STAFF RECOMMENDATION
122 South 12th Street
July 20, 2016

Application: New construction-addition and outbuilding; Setback determination
District: Lockeland Springs-East End Neighborhood Conservation Zoning Overlay
Council District: 06
Map and Parcel Number: 08309048100
Applicant: Van Pond, Jr.
Project Lead: Melissa.sajid@nashville.gov

Description of Project: The request is to construct a new rear addition and to construct an outbuilding that does not include a detached accessory dwelling unit. The outbuilding requires a rear setback determination from twenty feet (20') to ten feet (10').

Figure 2: 1957 Sanborn Map

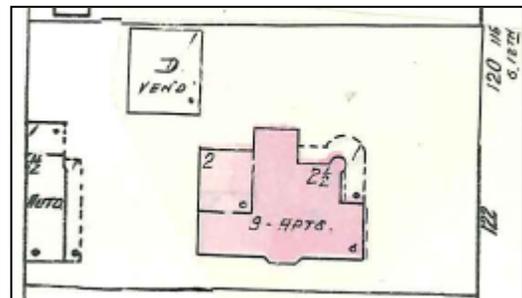
Design, Location & Removability: The new construction is located at the rear of the historic house, in accordance with design guidelines. The addition sets in two feet (2') from the rear corner on the right side and is bound on the left side by the existing building. The addition meets the requirement of the design guidelines for additions to be inset at least two feet (2') for two-story additions. In addition, the 1957 Sanborn maps indicate that the location of the addition is similar to a previous covered porch location (Figure 2).

2 Proposed Site Plan

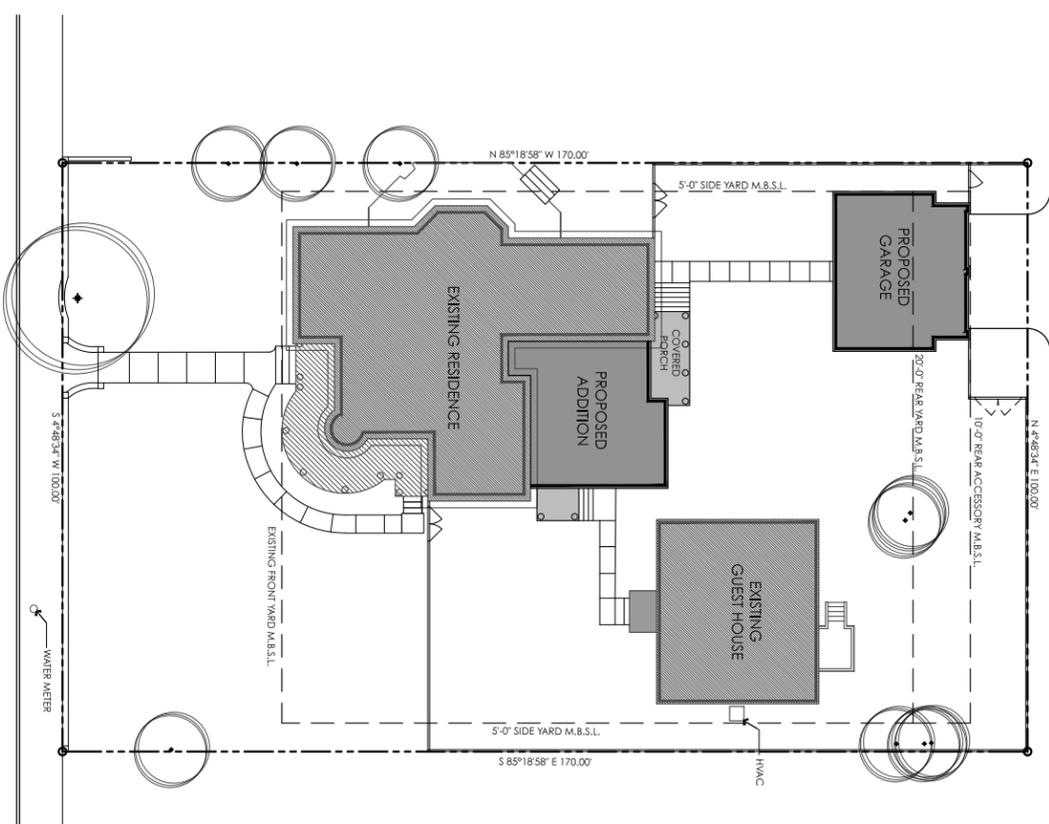
Setback: The new addition meets all base zoning setbacks. The addition will be located approximately twenty feet (20') from the right side property line and approximately thirty feet (30') from the rear property line. Staff finds that the project meets Section II.B.1.c. of the design guidelines.

The proposed outbuilding requires a rear setback determination. Since the total footprint of all outbuildings on-site exceeds seven hundred square feet (700 sq. ft.), the base zoning

requires that the new structure meet the full rear setback of twenty feet (20'). The applicant proposes to locate the outbuilding ten feet (10') from the rear property line. Staff finds that the proposed rear setback is appropriate since outbuildings were located historically at the rear of the property, close to or even on the rear property line. Furthermore, the 1957 Sanborn map (Figure 2) shows that there was previously an accessory structure located on the rear property line on this site. Staff recommends approval of the rear setback determination.

1 Proposed Side Elevation

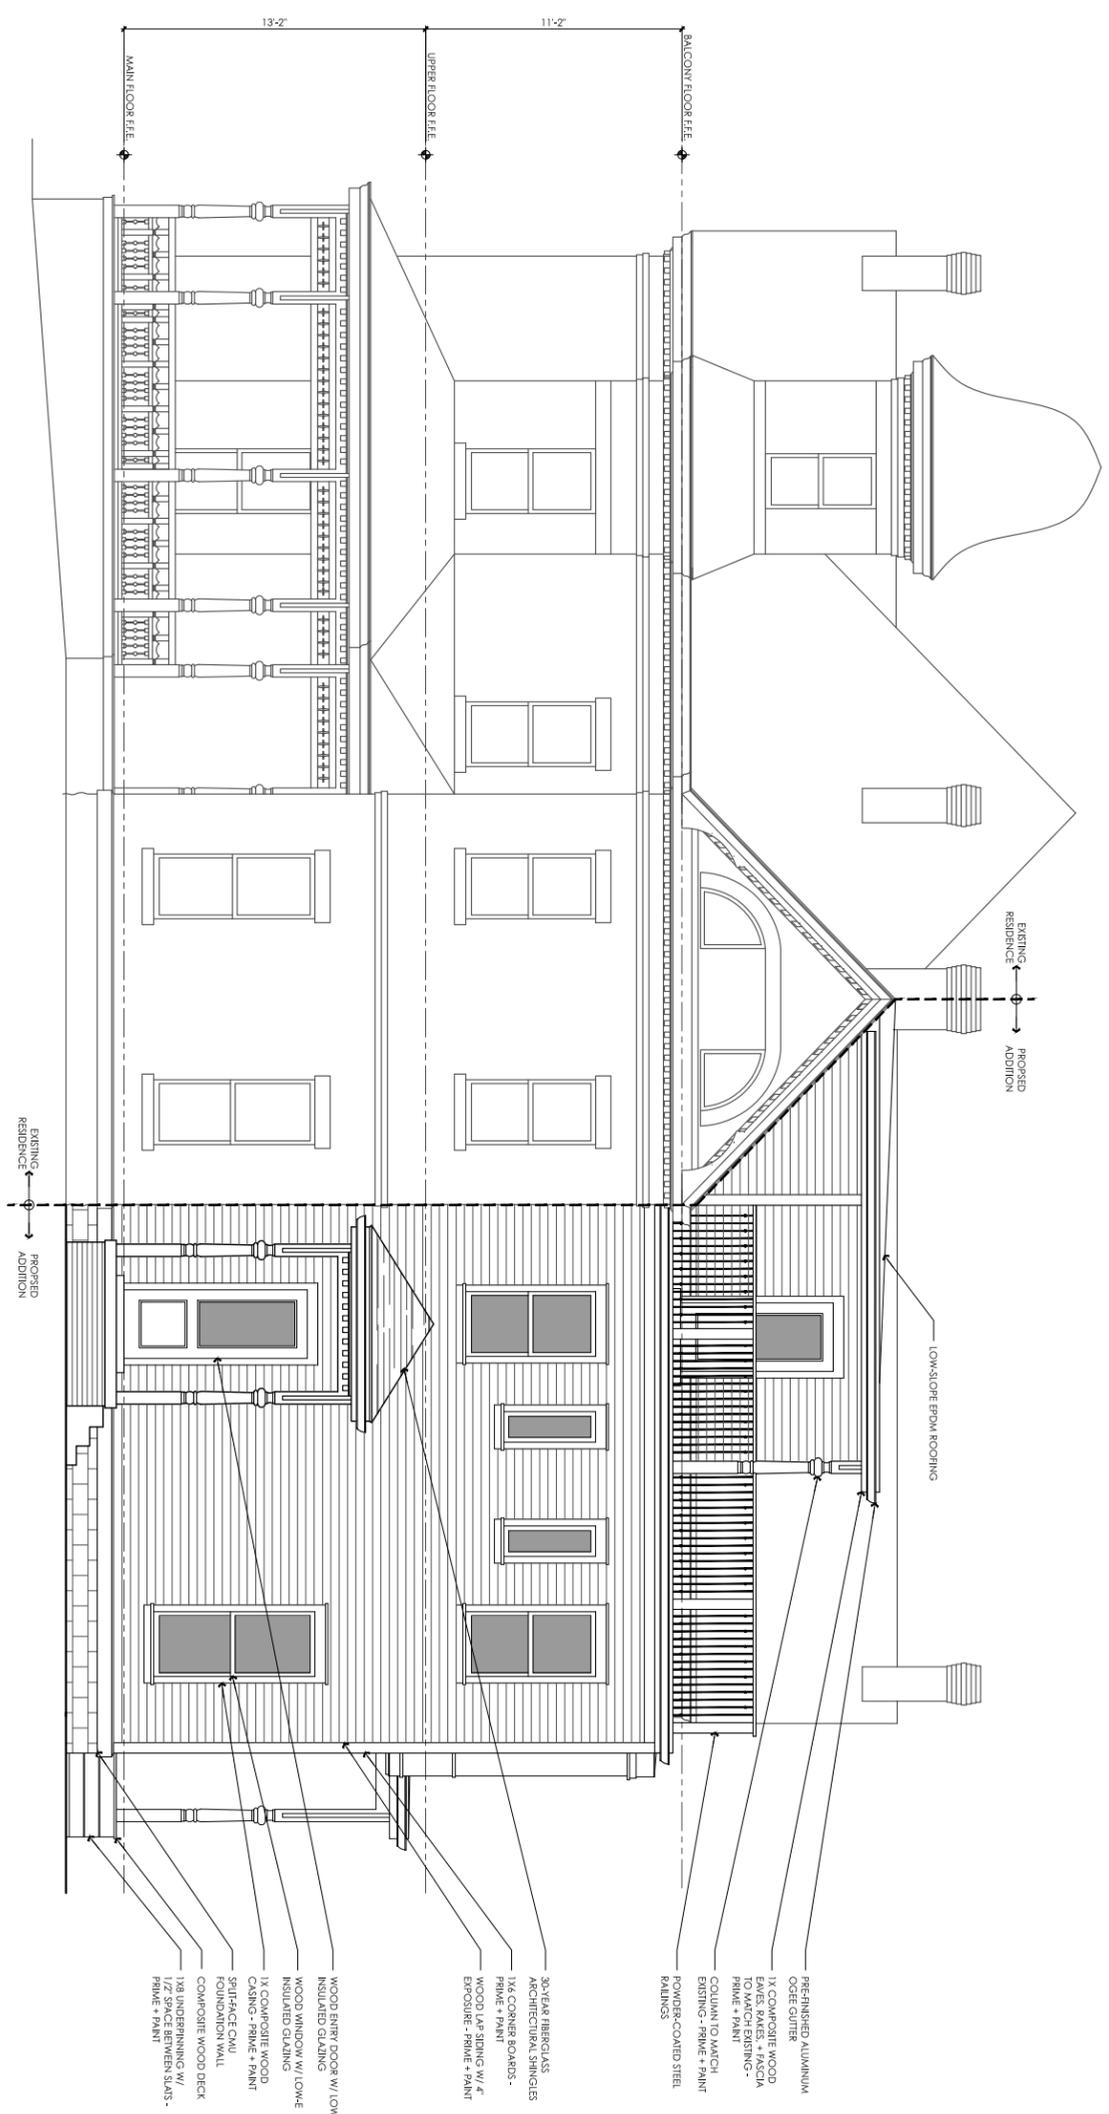
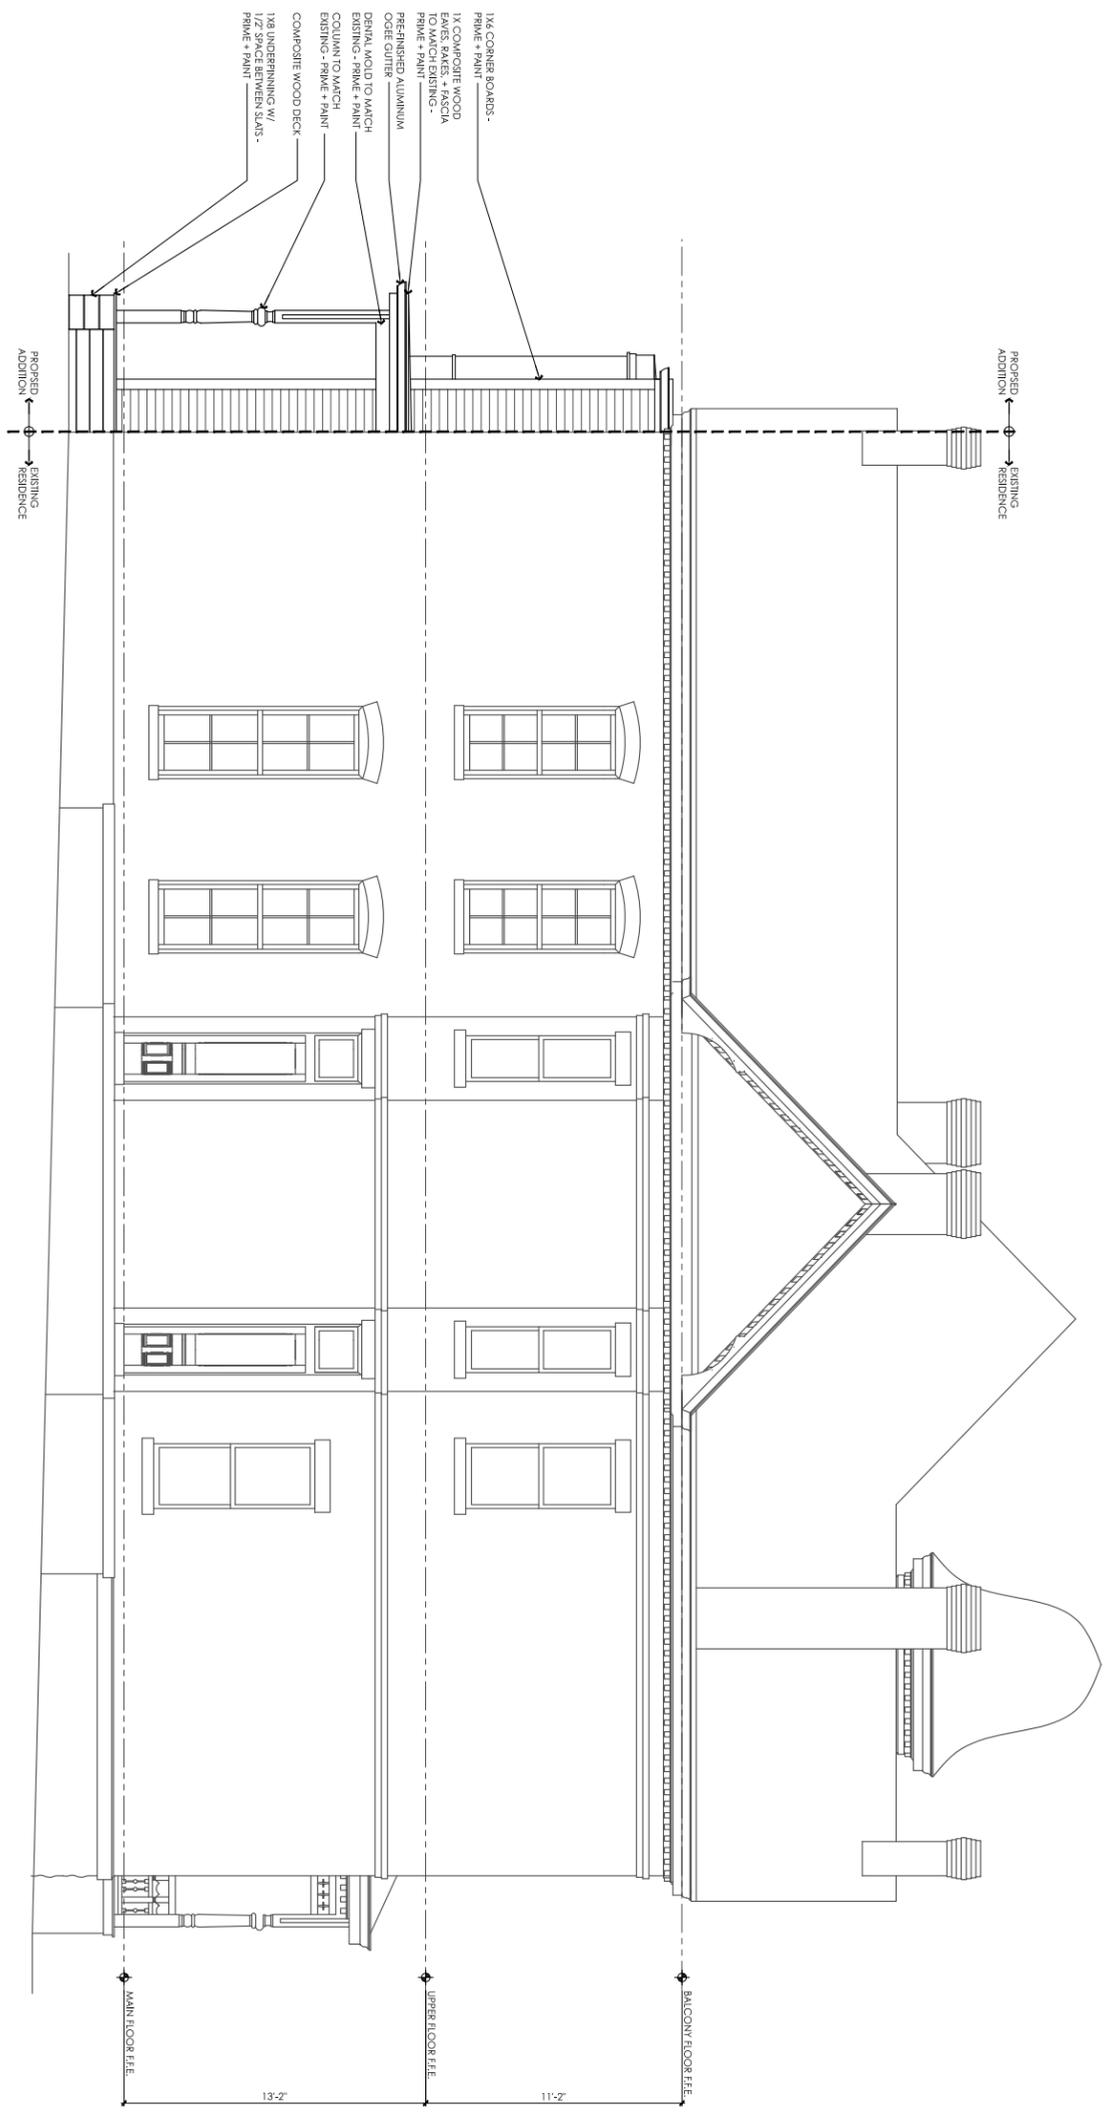
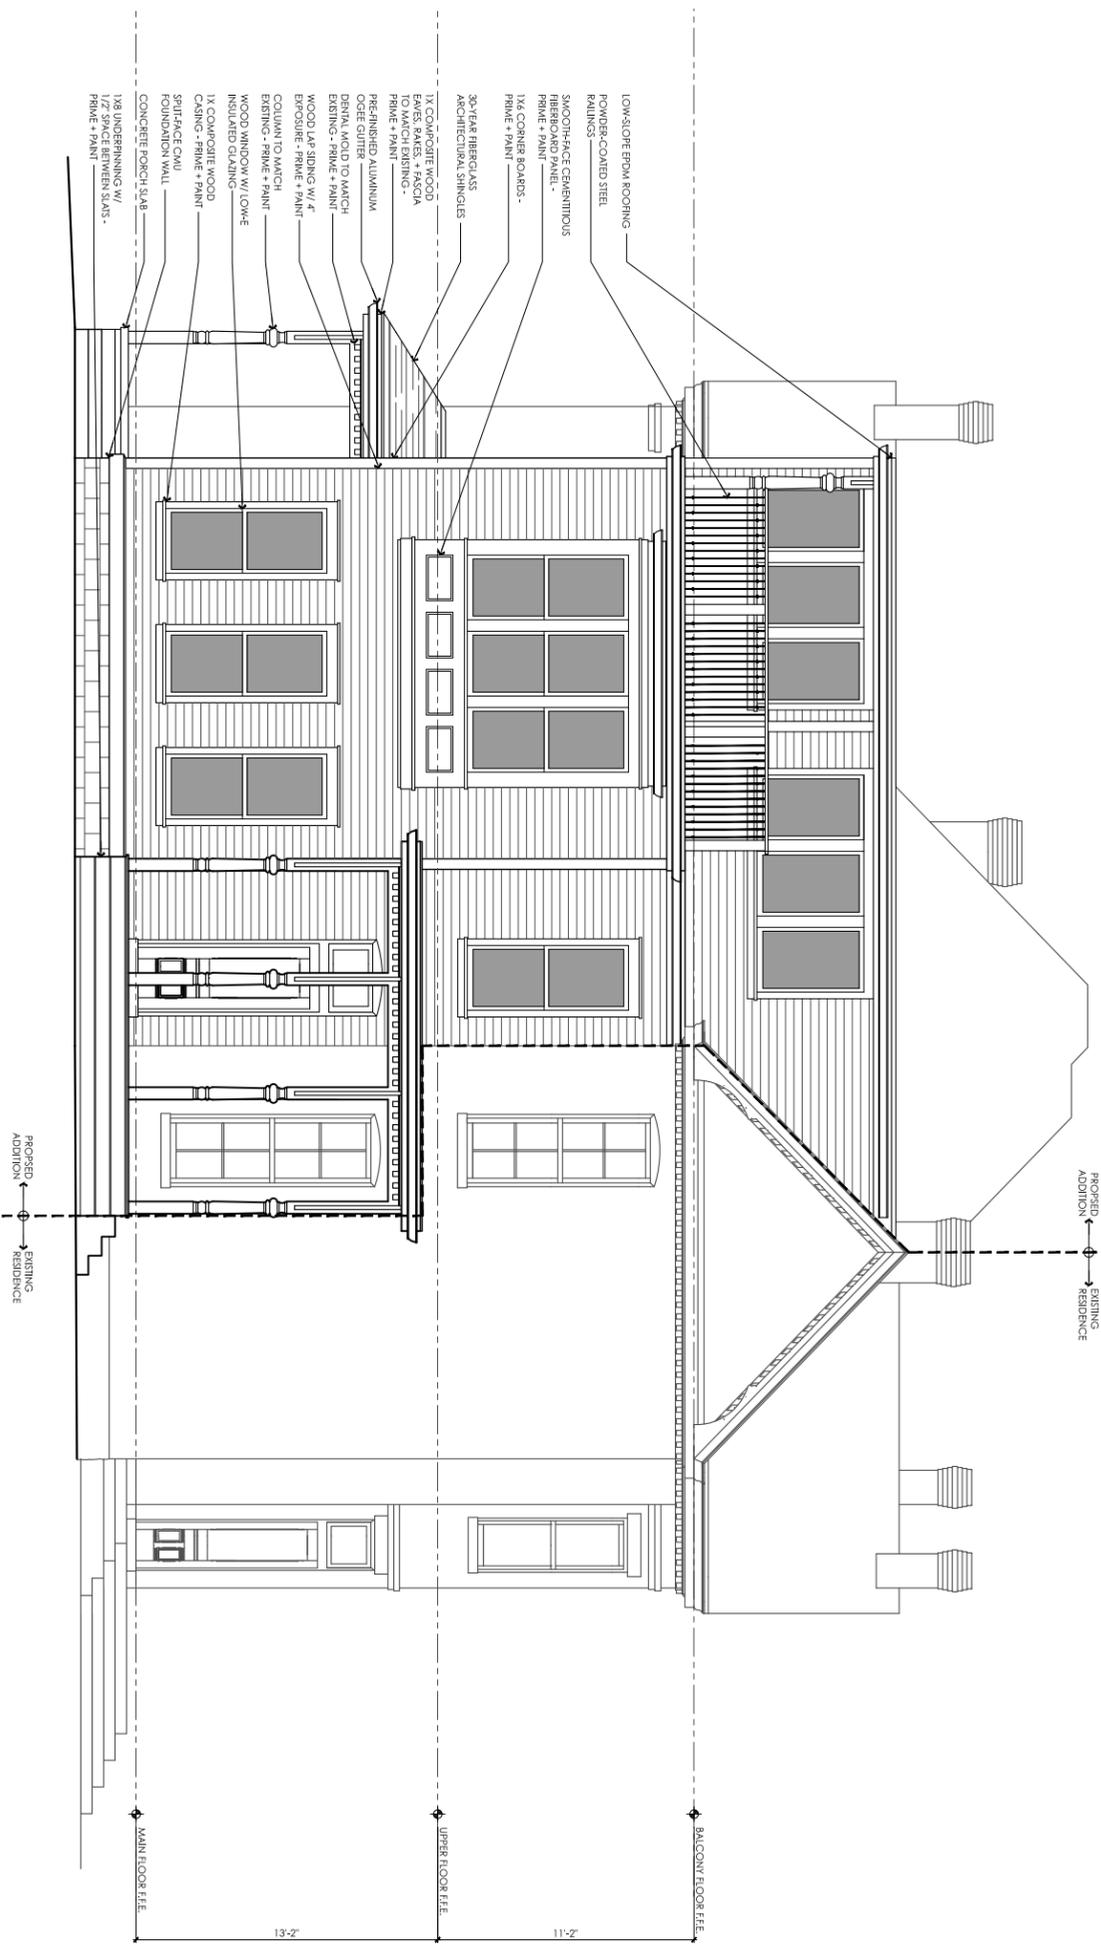
The addition has a maximum height that is approximately eight feet (8') less than the ridge of the historic house. The foundation line matches the existing foundation. Eave height on the addition is also similar to that on the existing house.

Materials: The addition is primarily wood lap siding with a reveal of four inches (4") with wood lap siding trim to match the house. The foundation will be split-face concrete.

The primary roof material will be EPDM, which is a flat roof system, and the porch roof on the right side will be fiberglass shingles. Staff finds that the proposed EPDM roofing is appropriate as it will be not likely be visible from the front of the house and is necessary due to the low slope. The deck on the rear will be wood, and the railings for the rooftop patio will be steel. Materials for the windows, doors, roof color, and porch posts are not known. Staff recommends including a condition that staff approve the final selection of the unknown materials prior to purchase and installation.

Roof form: The roof form of most of the addition is flat, that complements the existing historic house. The addition ties into an existing side gable on the right side and will not likely be visible from the street given the location of the addition. The roof of the proposed covered porch on the right side of the house will be gabled at a pitch similar to the historic house. The covered porch on the rear will have a flat roof. Staff finds that the proposed roof forms are compatible with the historic house and meet Sections II.B.1.e. of the design guidelines.

Proportion and Rhythm of Openings: The windows on the proposed addition meet the historic proportion of openings, being generally twice as tall as they are wide. There are no large expanses of wall space without a window or door opening. Staff finds the project's proportion and rhythm of openings to meet Section II.B.1.g.

With the condition that staff approve the final details, dimensions, and materials of windows, doors, roof color, and porch posts prior to purchase and installation, staff finds that the proposed materials meet Sections II.B.1.d. of the design guidelines.

1 Side Elevation - Garage

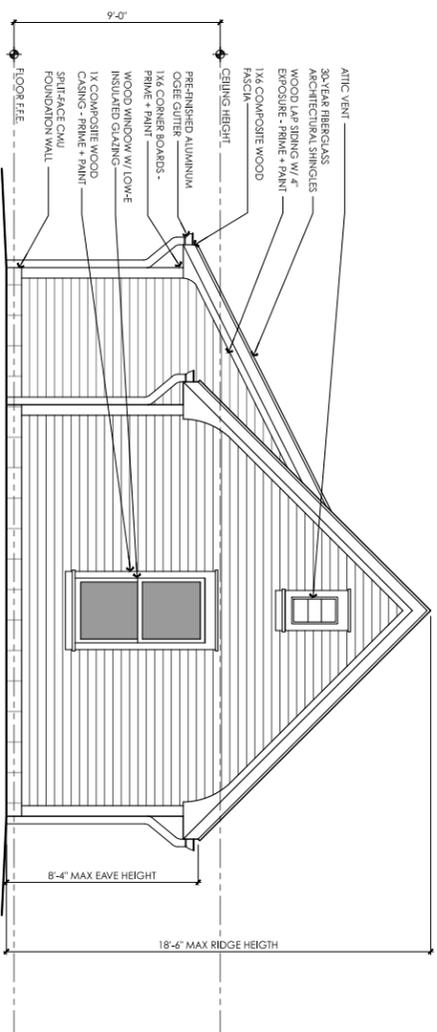
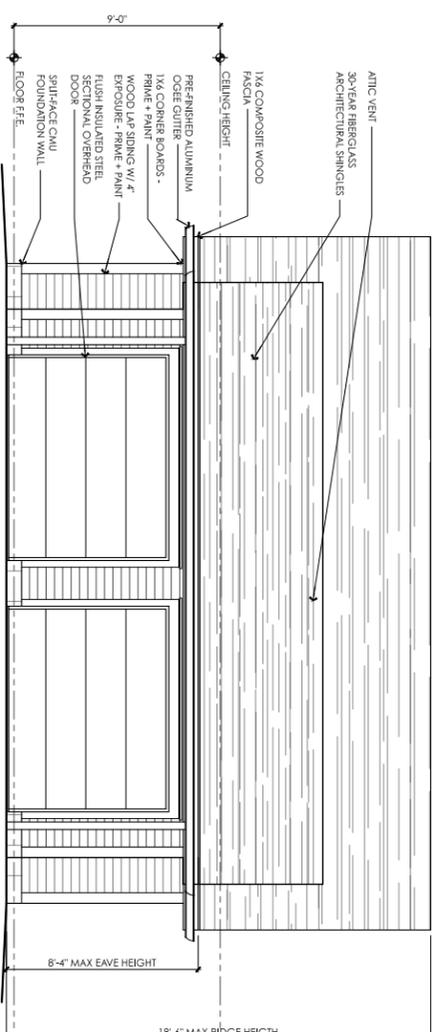
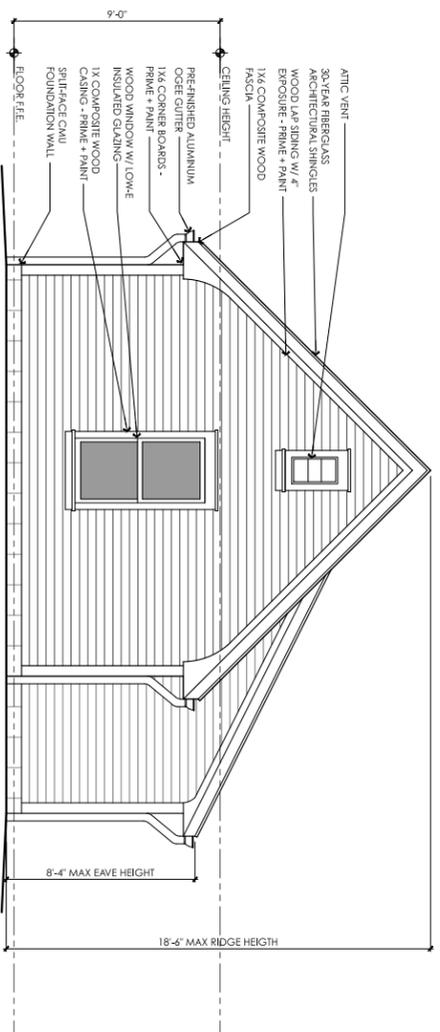
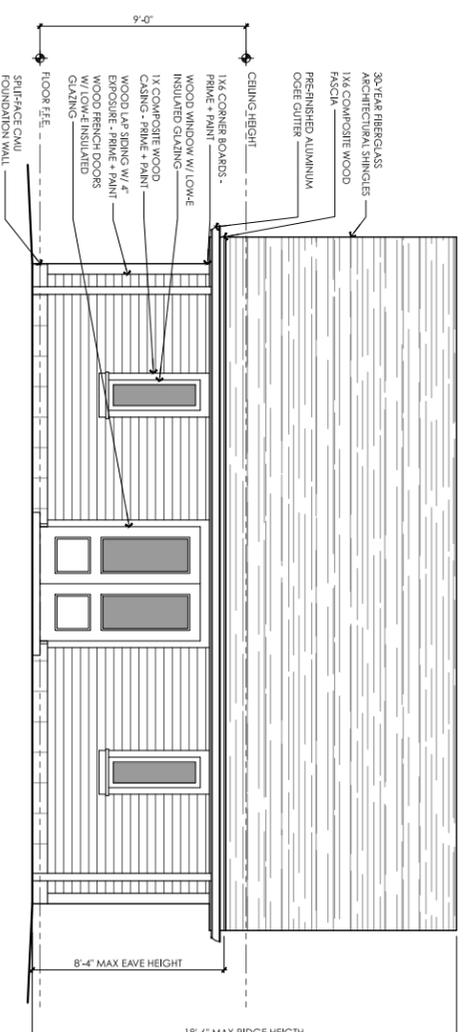
The plan proposes a single-story, two-bay detached garage that will be located in the rear yard behind the historic house. An existing guest house is located on the site and will remain. The outbuilding will be accessed via the alley and will have a footprint of six hundred and forty-two square feet (642 sq. ft.). Staff finds that the additional building is appropriate in this case since the property includes two full lots. The overall height of the outbuilding is approximately eighteen feet, six inches (18'-6") and includes an eave height of eight feet, four inches (8'-4").

The materials proposed for the outbuilding reflect the materials that are to be used on the primary house and include wood lap siding with a reveal of four inches (4"). The roof shingles will be fiberglass architectural shingles. The materials for the foundation will be split-face concrete. The materials for the doors, garage doors, and windows are unknown. Staff asks to approve the final selection of doors, windows, garage door and roof color prior to purchase and installation.
